# hill thalis

## **Letter of objection**

### **Barangaroo MP 06-0162 MOD 4 (Hotel Development, additional GFA and height)**

**Figure 1 -** Diagram overlaying existing and proposed alignment of Margaret Street. The alignment has been shifted southwards and the street vista now blocked by development.

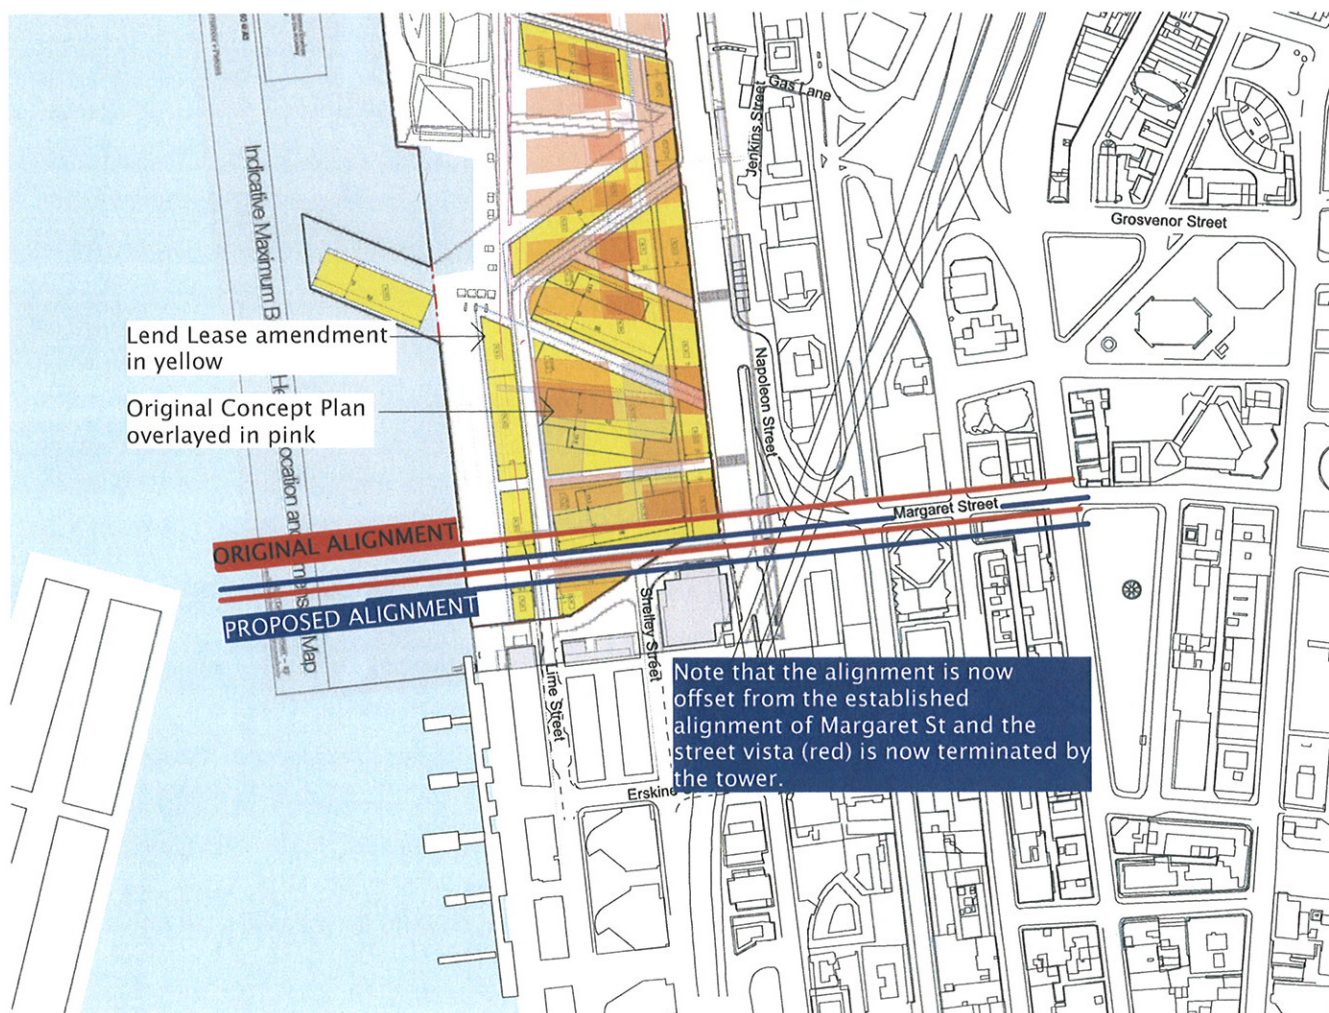
On closer examination, the proposed alignment for Margaret Street West has been shifted southwards. This is not acknowledged in the proposed amendment, and no overlay plan showing the comparative positions is included. A drawing comparing the alignments is appended to this submission as Figure 1.

The impacts of this can also be determined by viewing the applicant's model along the Margaret Street corridor. The view to the water is now terminated by the eastern and southern flank of one of the 40+ storey commercial towers on block 2 and no longer provides a vista to the harbour and the open sky.

The consolidated Concept Plan requires that a vista along Margaret Street to water and open space be retained. Now this key public domain vista has been stolen – and secured for the sole benefit of the Lend Lease development. No argument as to why this key public view has been blocked and subsumed for private benefit has been put forward.

This change is contrary to the approved Concept Plan and the proponent's own claims – and should not be permitted.

**Figure 2 -** Comparison of Concept Plan public domain and proposed amendment. The generosity, extent, and connectivity of the public domain has been completely undermined in the proposed amendment.

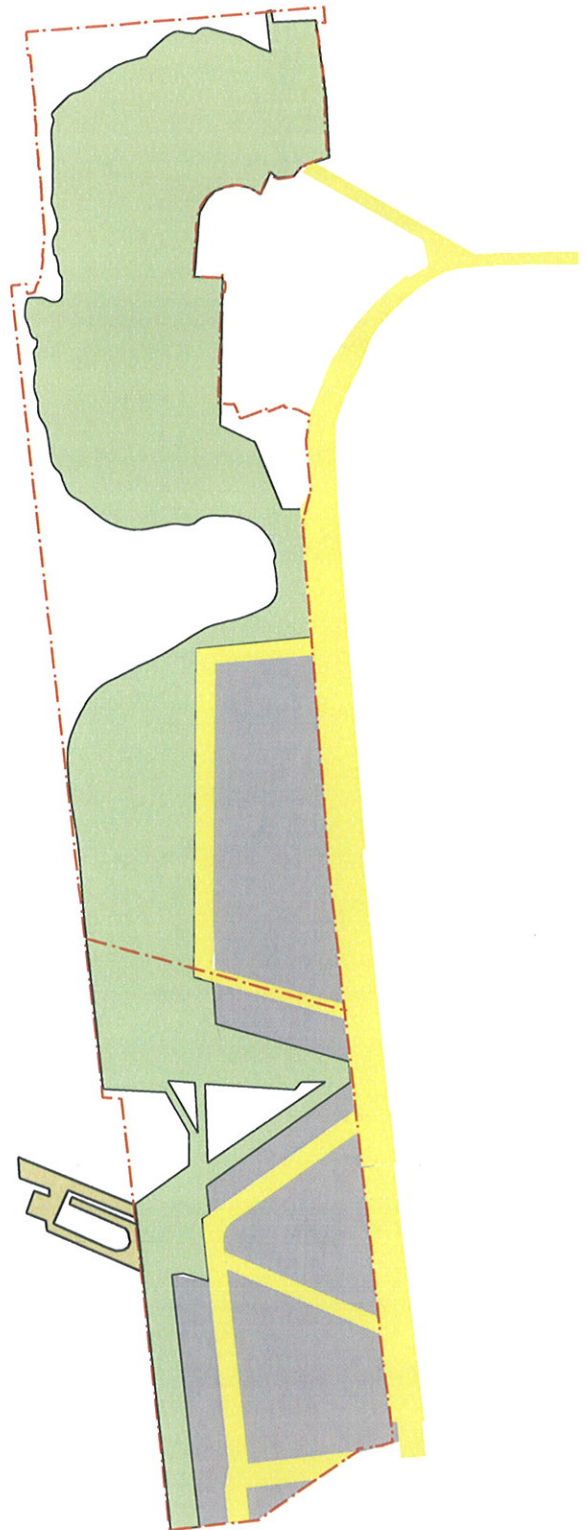
The connectivity of the proposal is abysmal. Every strong street connection embodied in the original Concept Plan that it is possible to make has been removed, cut, detoured or otherwise severely compromised. A comparison of quantum and connectivity of the public domain in the approved Concept Plan and the proposed amendment is included as Figure 2.

While desirable, the pedestrian connections are second order, and not enough to make up the deficit caused by the mutilation to the approved street pattern. It should be redesigned to make real city connections and a real city scale, as a public, open and engaging public domain.

**Figure 3 -** Comparison of Retail frontage proposed with existing Sydney areas. Shows that 2.1km of retail/commercial frontage is proposed - equivalent to almost all the retail frontage from Town Hall to Wynyard Station on George Street.

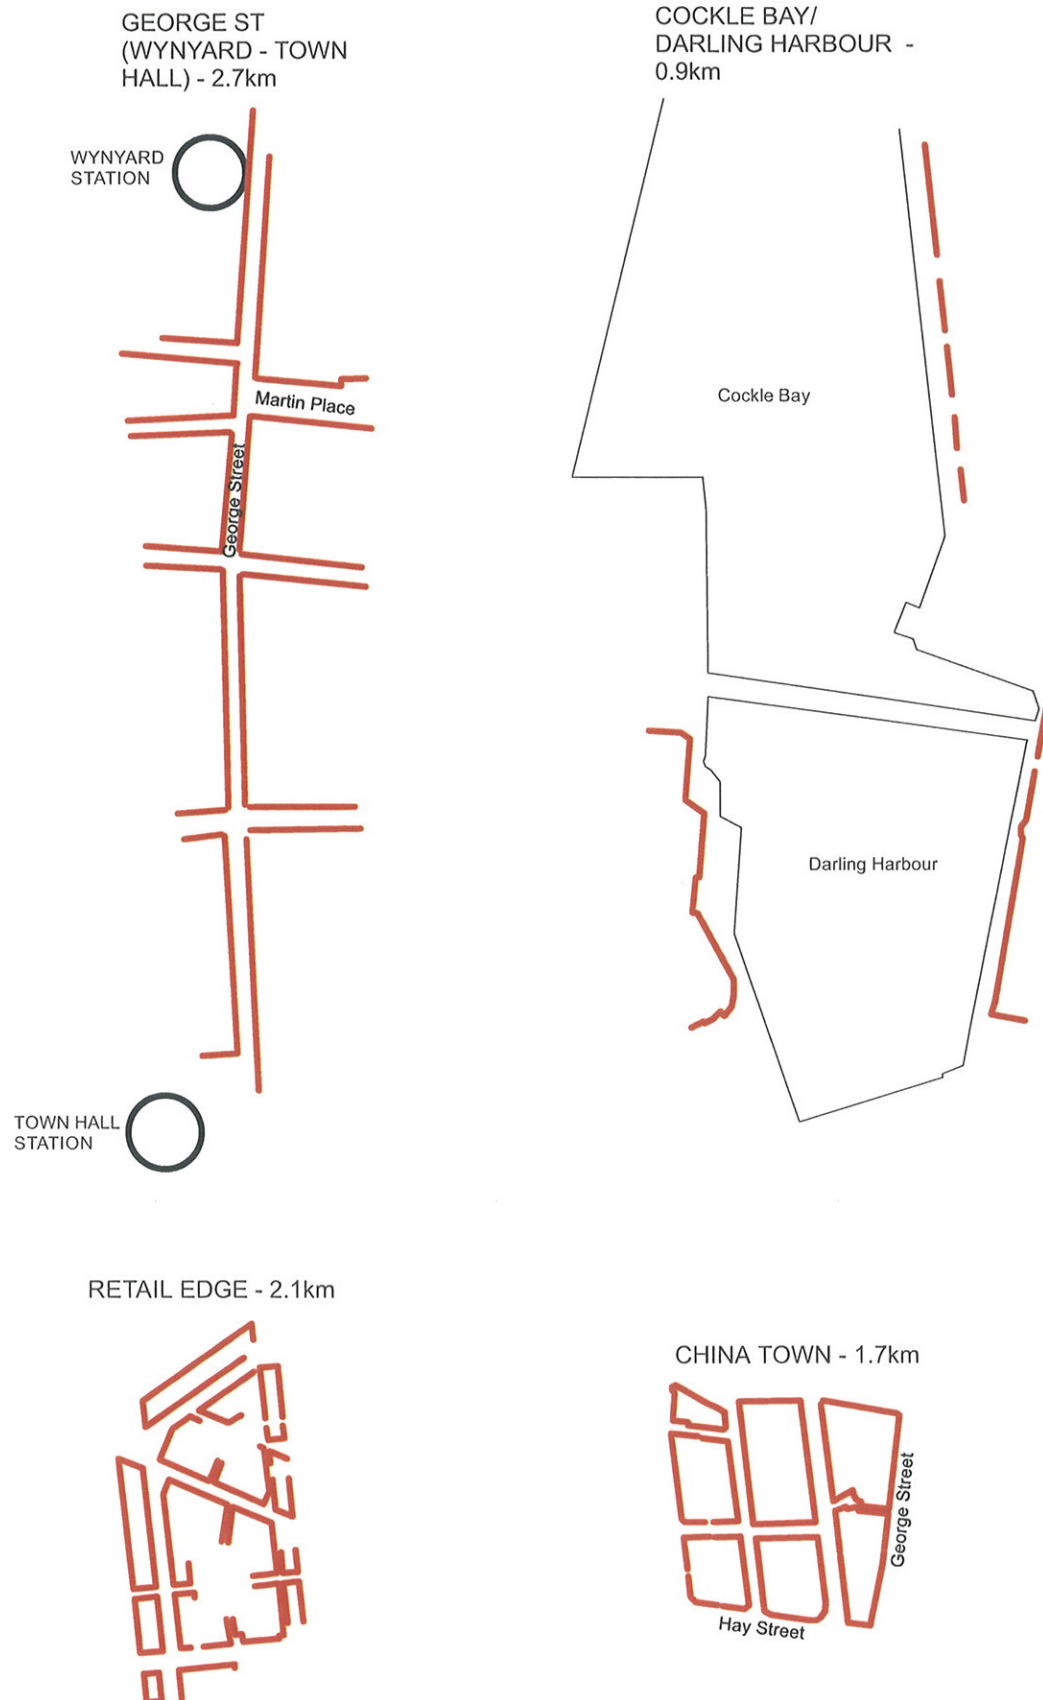
To put this in context, we have included some analysis drawings as Figure 3. This shows the entire retail frontage of Cockle Bay and Darling Harbour along the waterfront totalling 0.9km. The retail frontage of China Town has 1.7km frontage. The quantum of retail frontage being considered is almost equal to that between Wynard Station and Town Hall along George Street with much of the side street frontages included.

**Figure 4** Comparison of existing Concept Plan envelopes to proposed envelopes

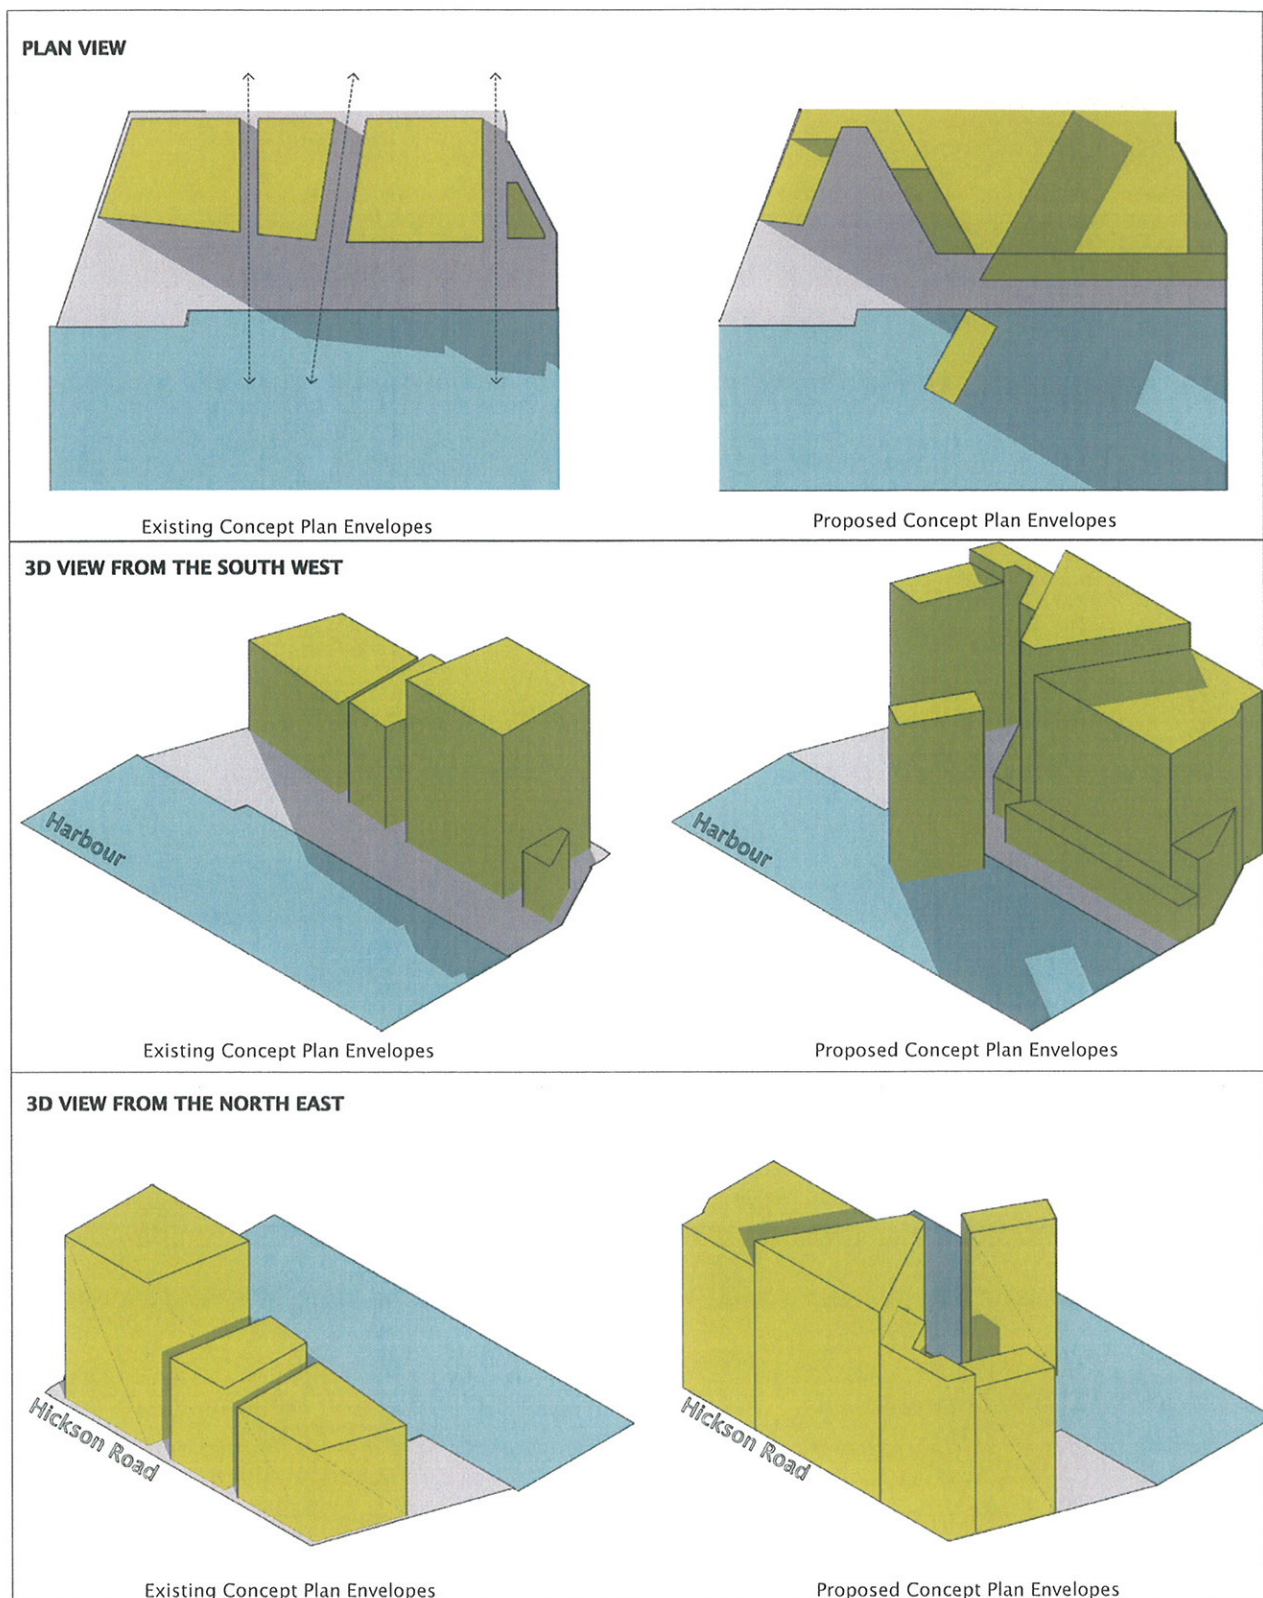
We have taken this opportunity to document a comparison of the approved Concept Plan envelopes and the current proposal in plan and three-dimensional form. This is appended to this submission as Figure 4. We have also prepared an elevation comparison of the original competition scheme, the approved concept plan envelopes and the proposed amended envelopes, appended as Figure 5.

NOTE THAT THE PROPOSED AMENDED ENVELOPES ENTIRELY SUBSUME ALL PROPOSED STREETS  
POTENTIALLY ALLOWING FUTURE DEVELOPMENT TO ENCROACH UPON THESE AREAS

**Figure 5** Comparison of proposed heights of competition scheme, approved Concept Plan envelopes and proposed amendment

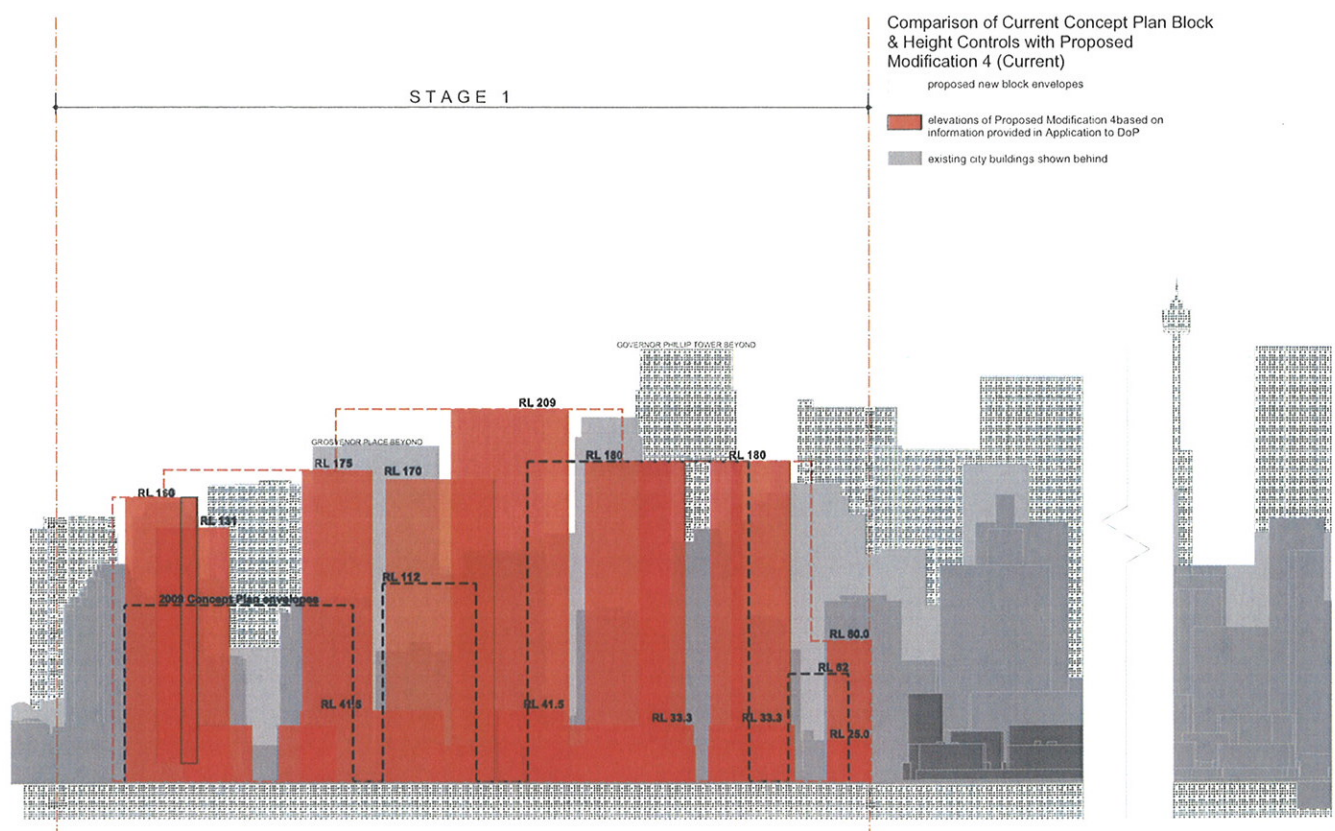
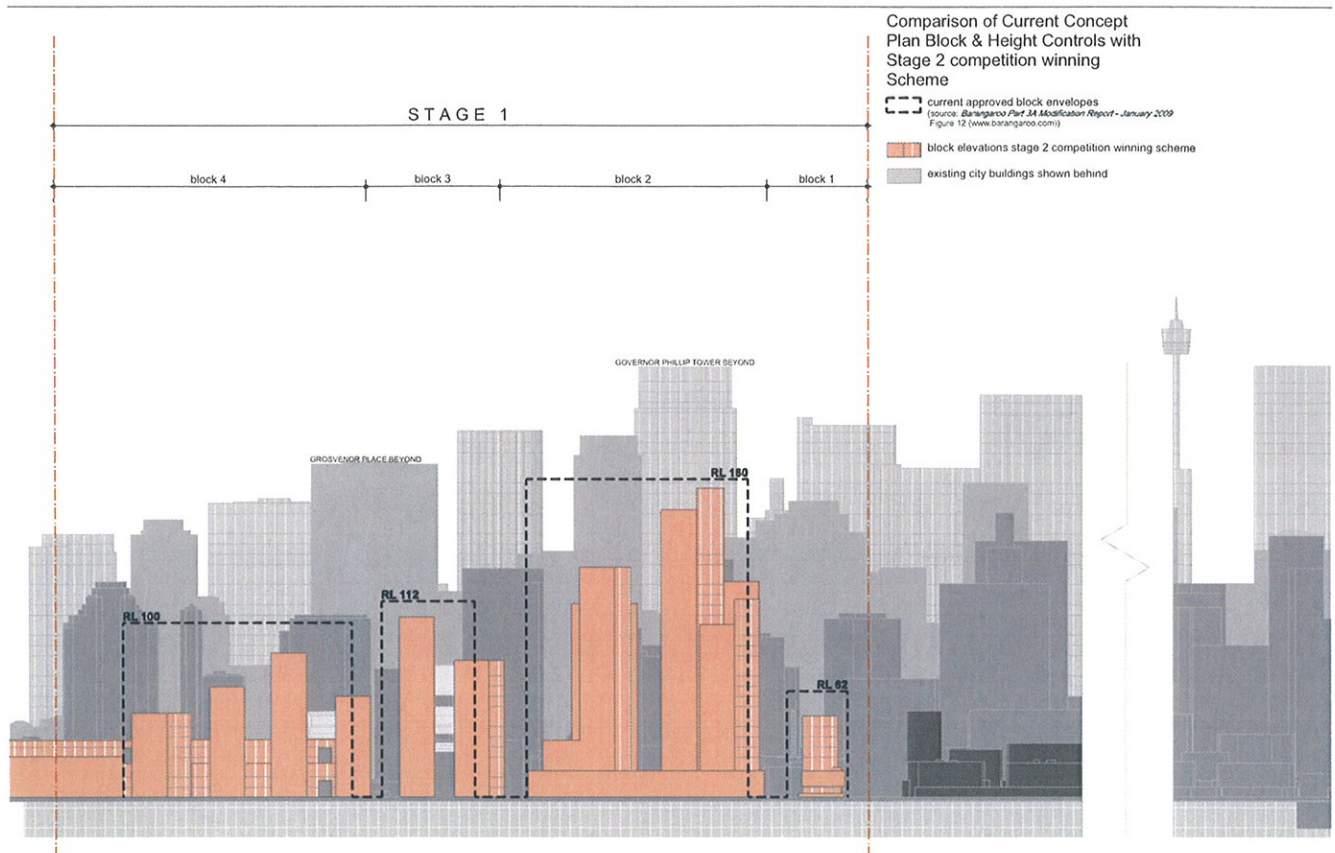
Unsurprisingly, this reveals an enormous increase in the bulk and scale of the development from that envisaged by the competition-winning proposal.

**Figure 6** Adjustment of applicant's height comparison to show full bulk of proposed buildings

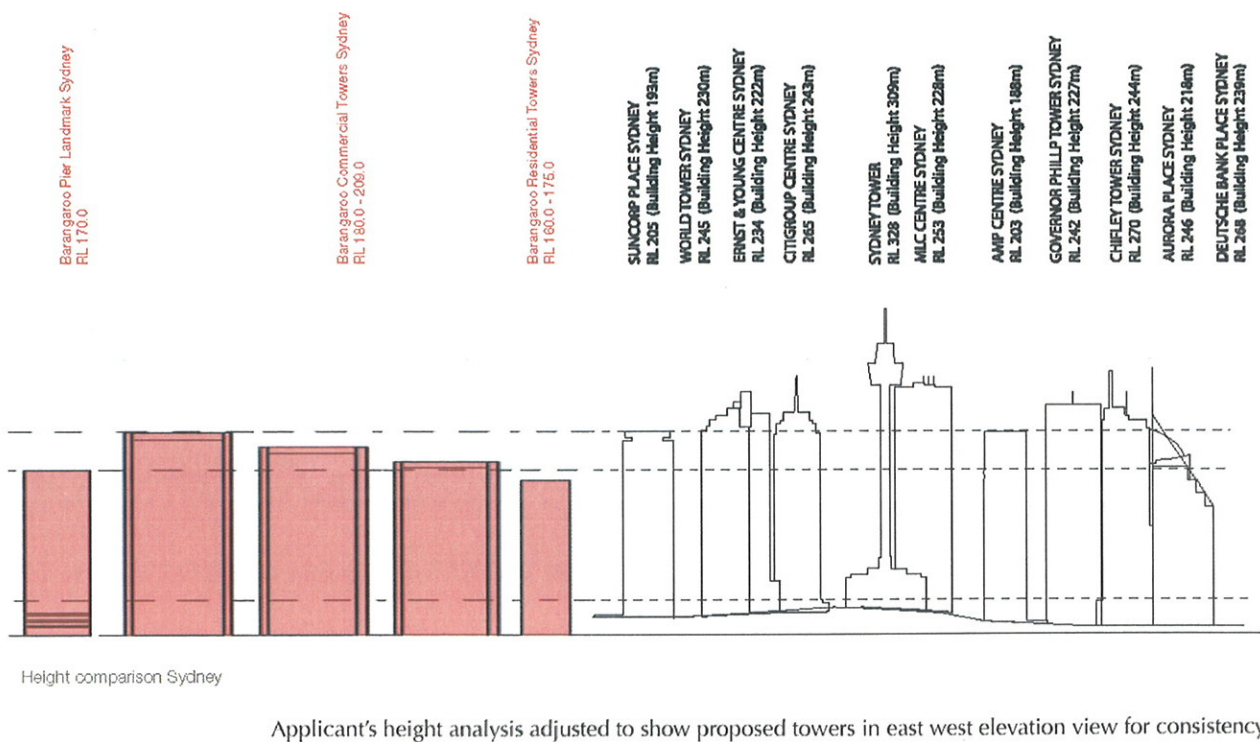
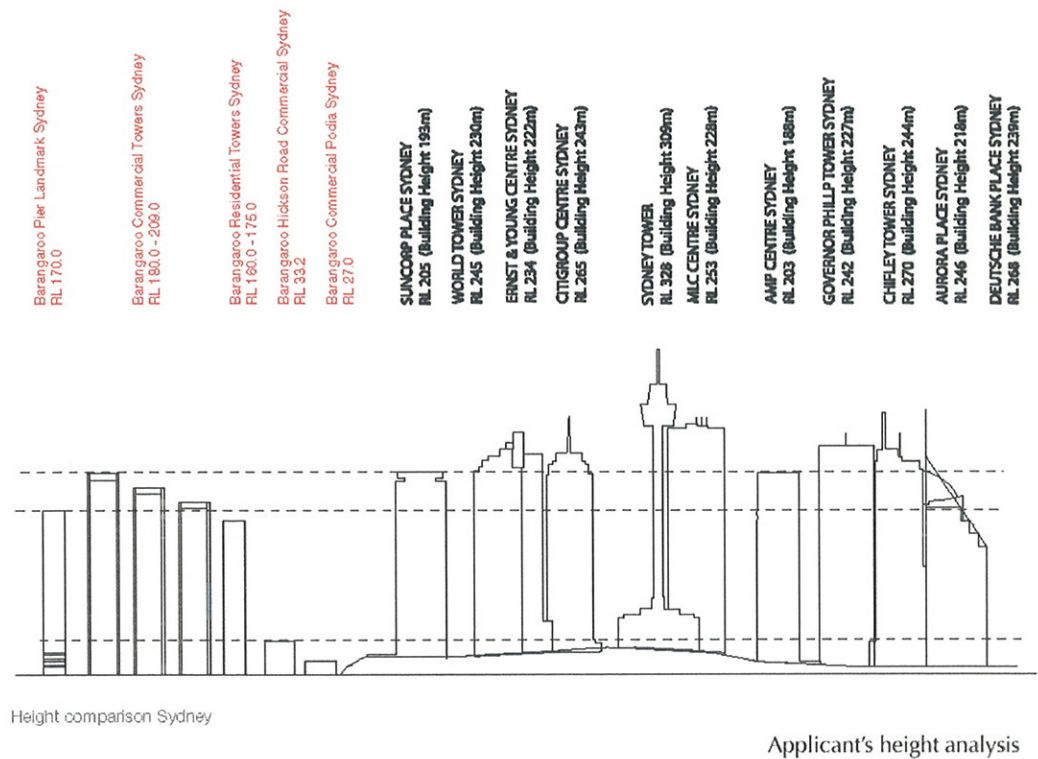
The applicant has included a comparison of the proposed buildings to those existing in the city. Again, this is done in a totally misleading manner – presenting all of the city buildings with their long elevations facing the viewer, but showing the short side of the applicant's tower slabs. We have adjusted this drawing, to accurately represent the bulk of the proposed buildings against the city towers – see Figure 6. The radically overscaled nature of these floorplates is immediately apparent.

While we note that a degree of flexibility is required in built form envelopes, the 'flexibility' being sought here is of such a quantum that one can only interpret it as a trojan horse for a future modification for ongoing increases in floorspace and bulk.
